During DPA investigations on PHL50 relays at Tesat it was found that materials have been used which are not compliant to the requirements of the ESCC specifications.

ESCC3602/014, ESCC23500:

Figure:	23
S/N:	6
Magnification:	See scale bar

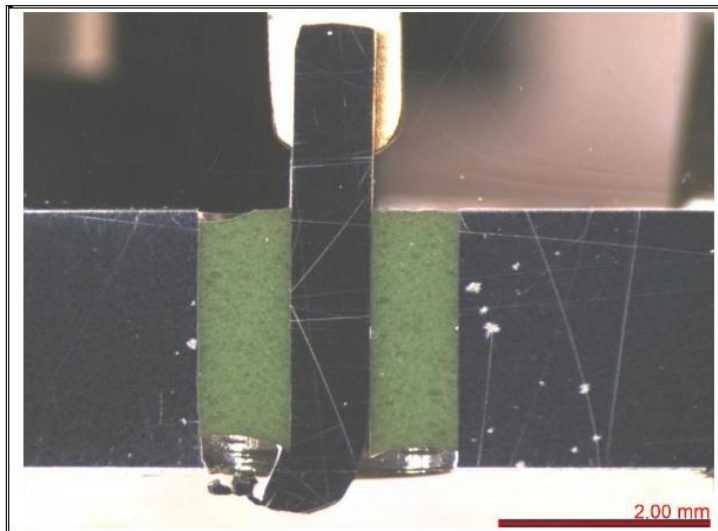
It was found that the materials of the relays delivered to Tesat are correct but the definition of the materials in Para. 4.4.2 of the detail specification ESCC3602/014 can be misunderstood. In Para. 4.4.2 the materials of the contacts are defined, but they are called terminal material (... for main contacts the terminal material shall be Type "O" ...).

Comments:

View onto the cross sectioned FeNi hook terminal. According to specification ESCC3602/014 for the hook terminals a copper core under the FeNi finish was expected.

The materials were checked with EDX (Energy-dispersive X-ray spectroscopy).

The main contacts are of type "O" (pure silver) but not the terminals. The word "terminal" has to be removed in Para. 4.4.2.
